STATE OF OHIO
DEPARTMENT OF TRANSPORTATION
HUR-CR 11-2.96
BASELINE ROAD/BROADWAY ST.
VILLAGE OF PLYMOUTH
HURON COUNTY
RICHLAND COUNTY

REPLACEMENT OF A DETERIORATED WOOD BEAM BRIDGE OVER ASHLAND RAILWAY IN VILLAGE OF PLYMOUTH ON EXISTING HORIZONTAL ALIGNMENT AND MODIFIED VERTICAL ALIGNMENT WITH APPROACH ROADWAY WORK.

ADDENDUM 1

CROSS SECTIONS - ASHLAND RAILWAY
STA. 4307+17.62 TO STA. 4307+42.83

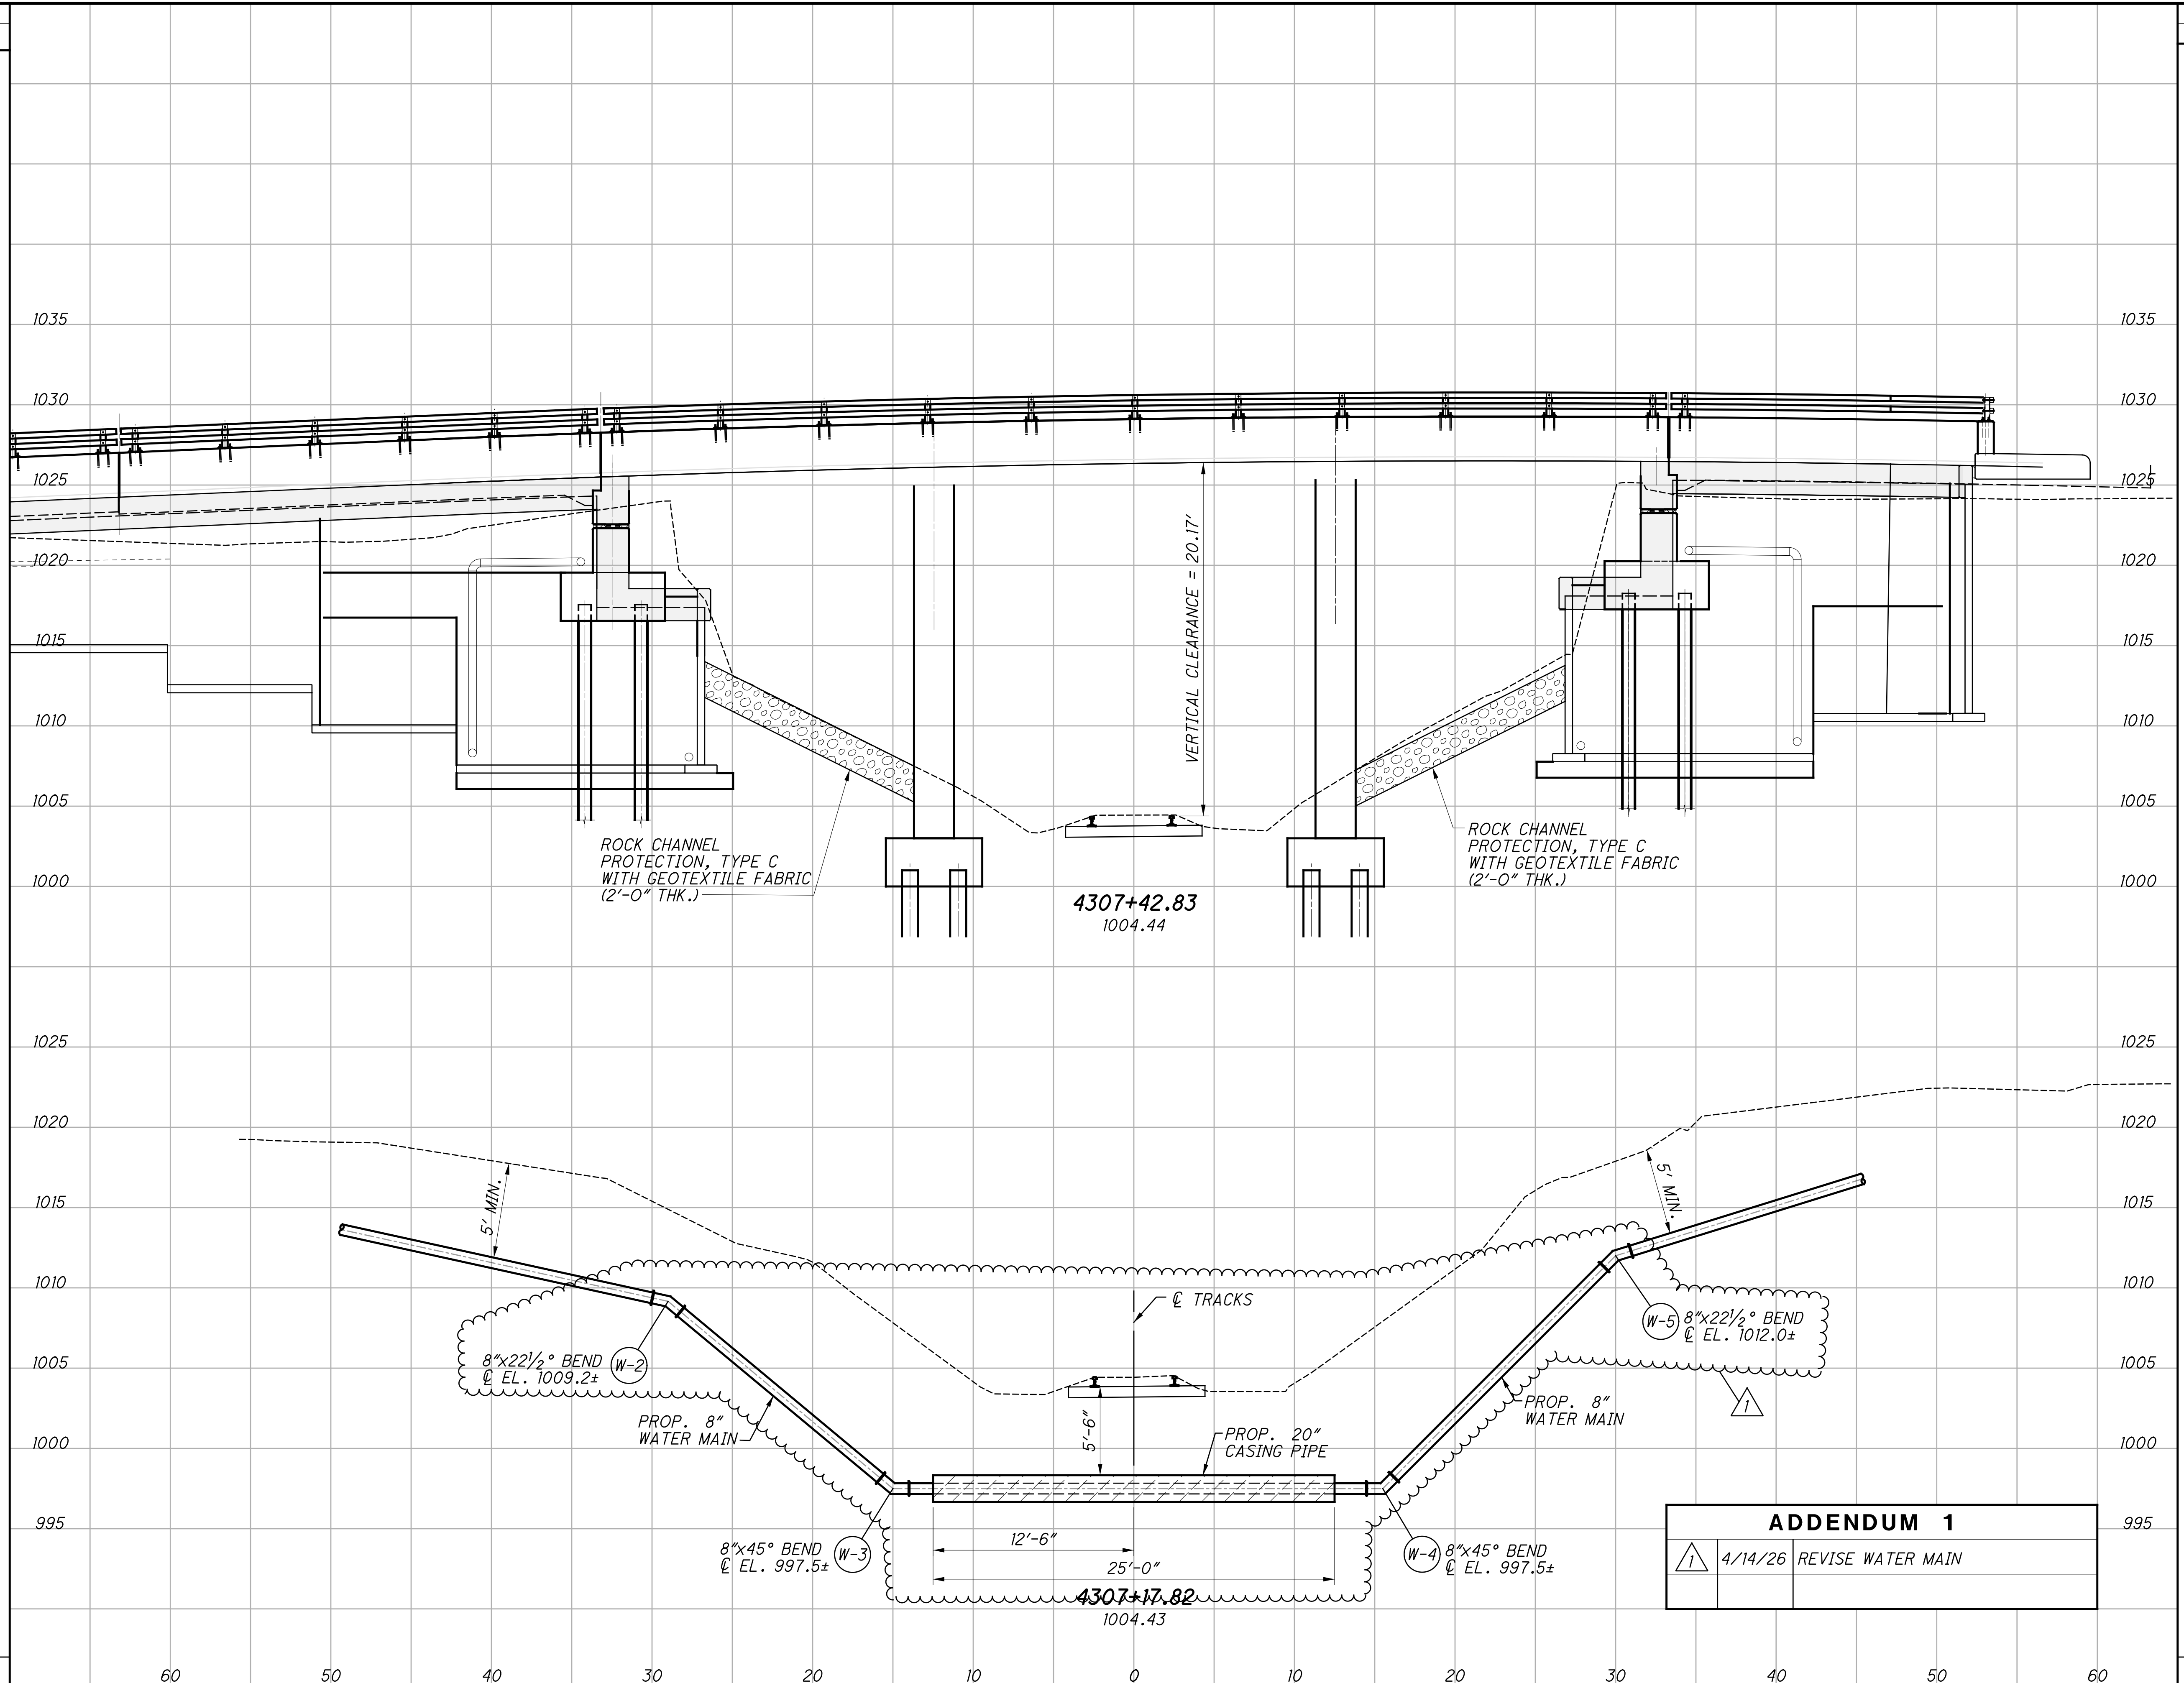
| ADDENDUM 1 | | |
|------------|---------|-------------------|
| 1 | 4/14/26 | REVISE WATER MAIN |

INTERSECTION DETAIL
CR 11 (BASELINE RD./BROADWAY ST. AND BELL ST./McINTIRE LN.)

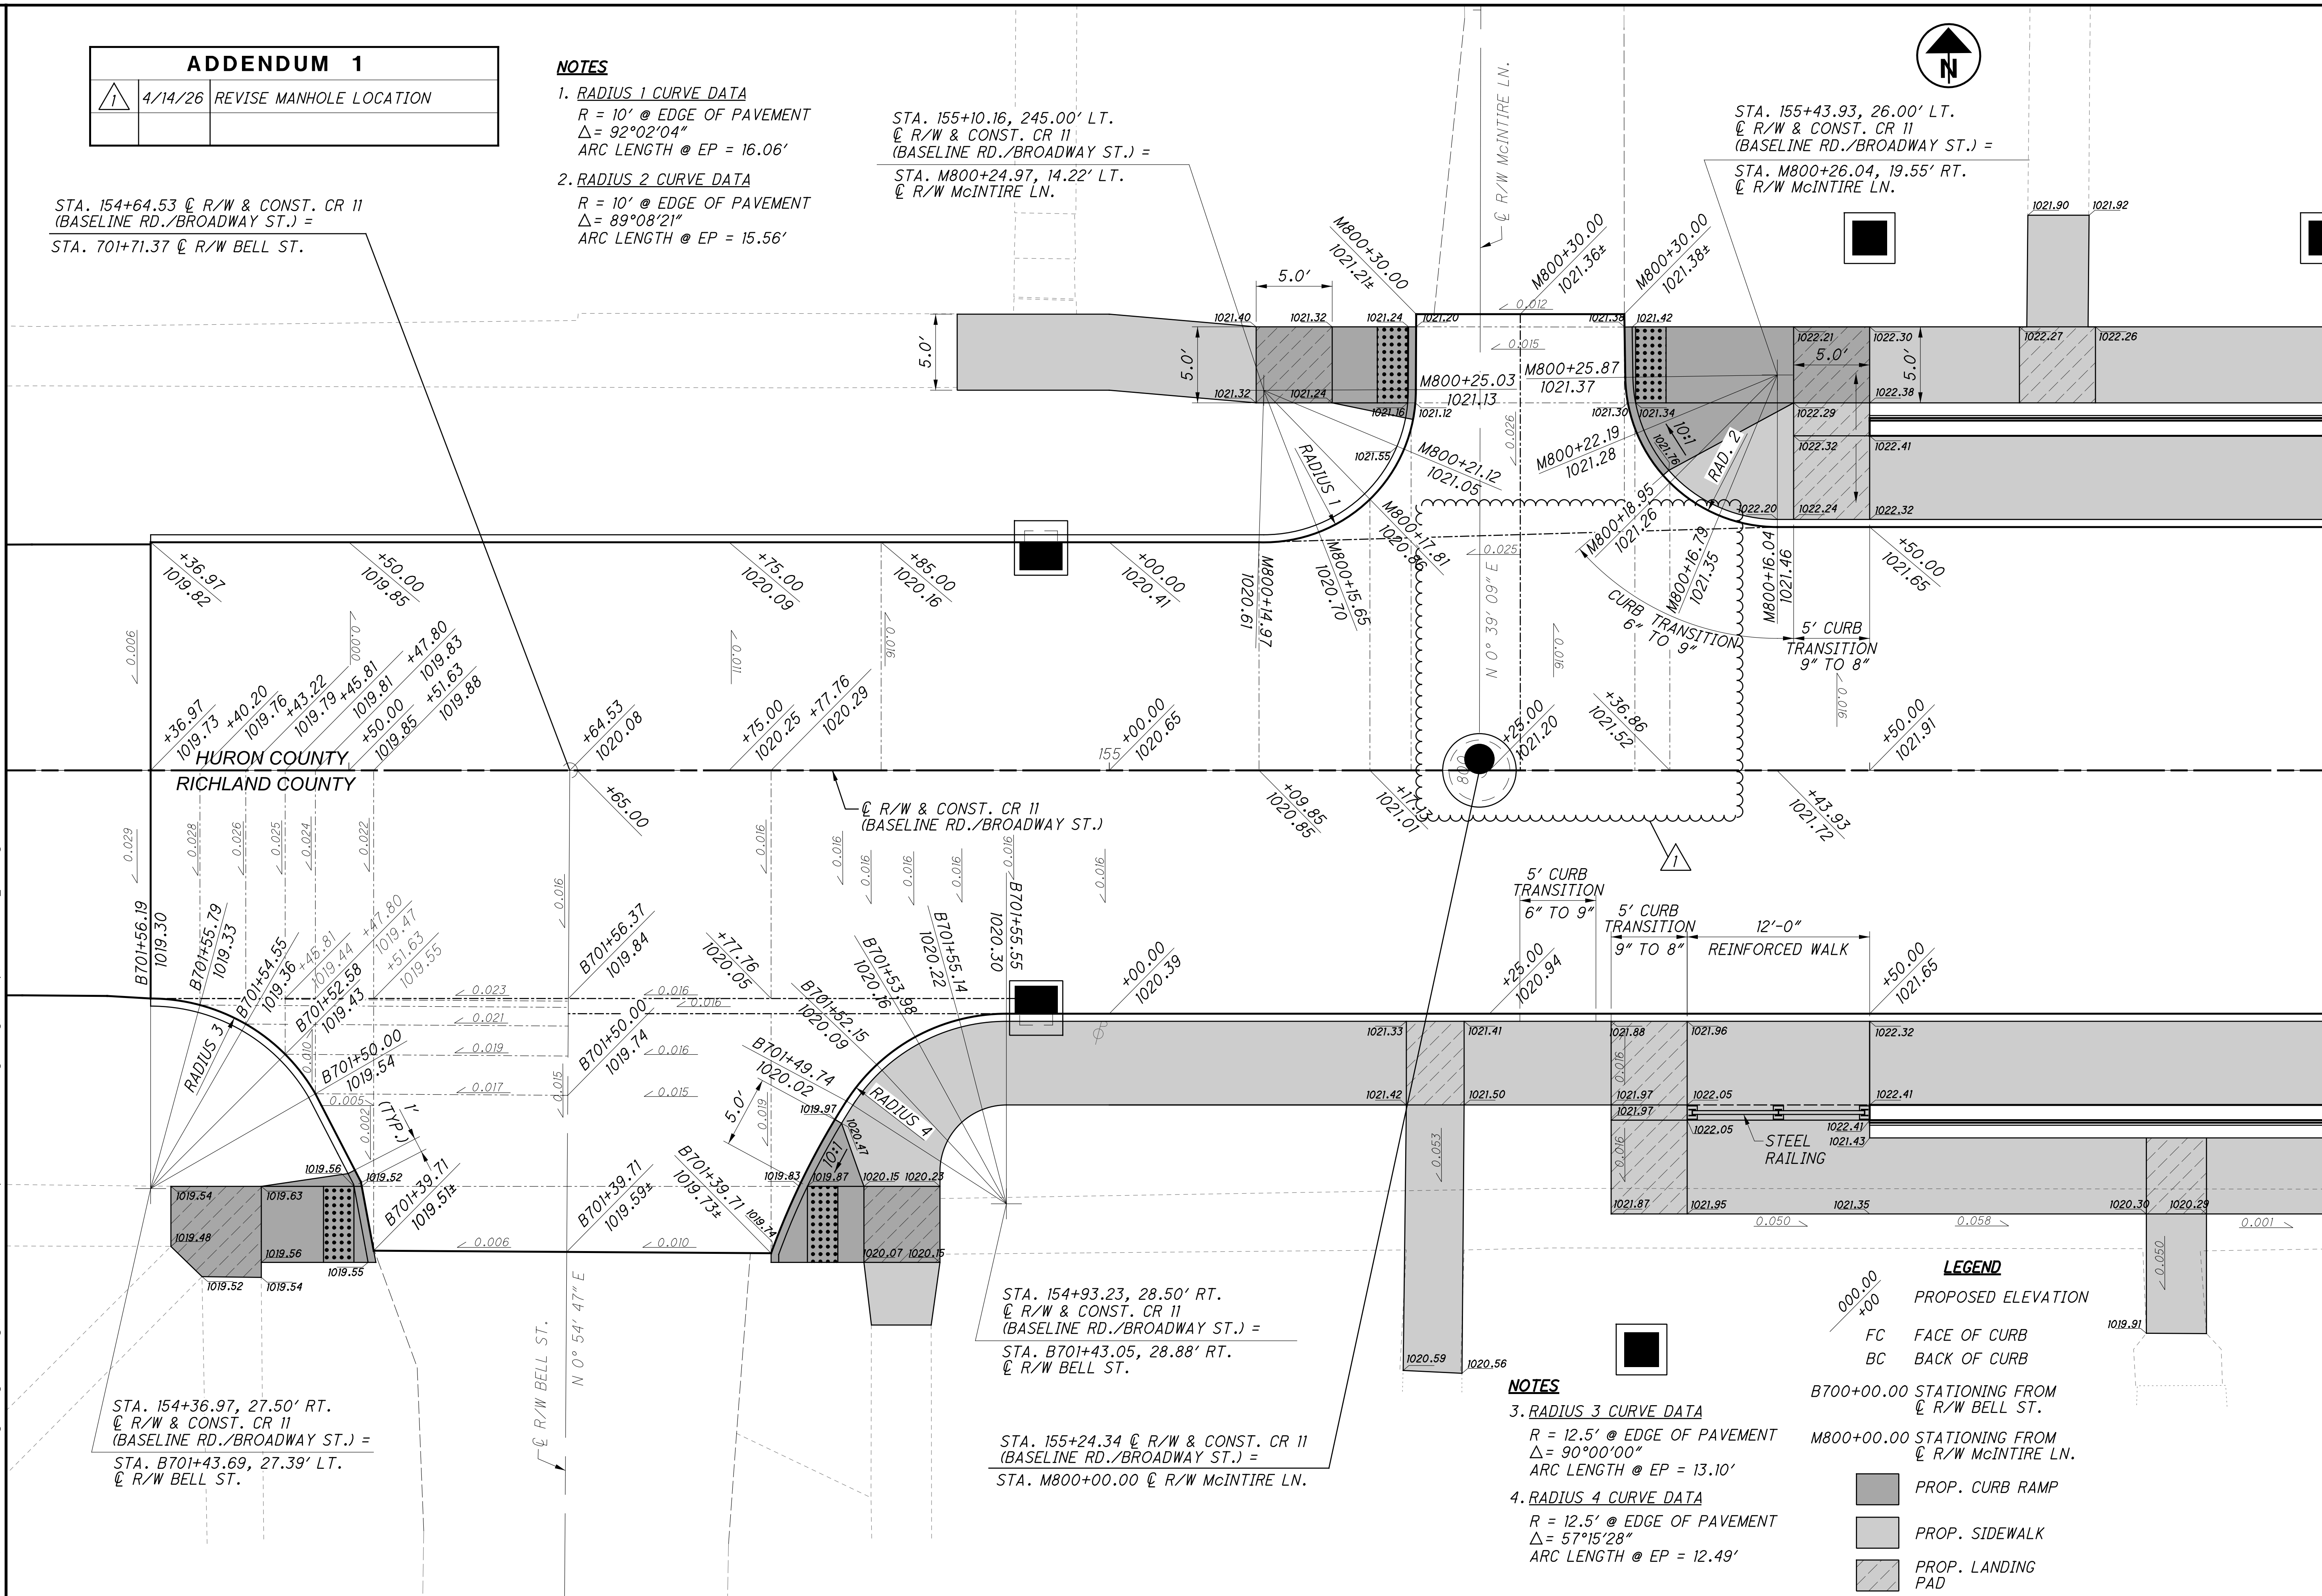
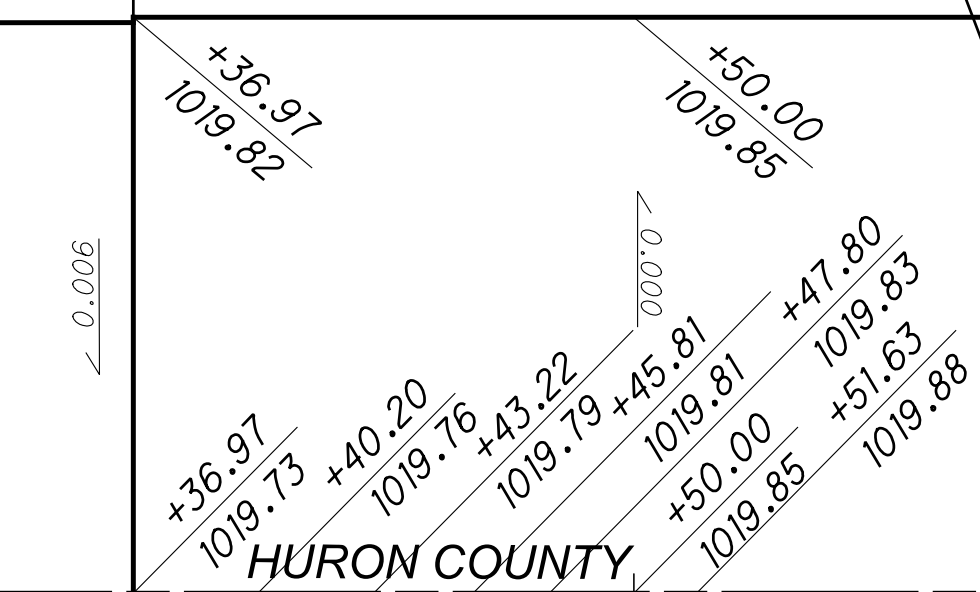
| ADDENDUM 1 | | |
|------------|---------|-------------------------|
| 1 | 4/14/26 | REVISE MANHOLE LOCATION |
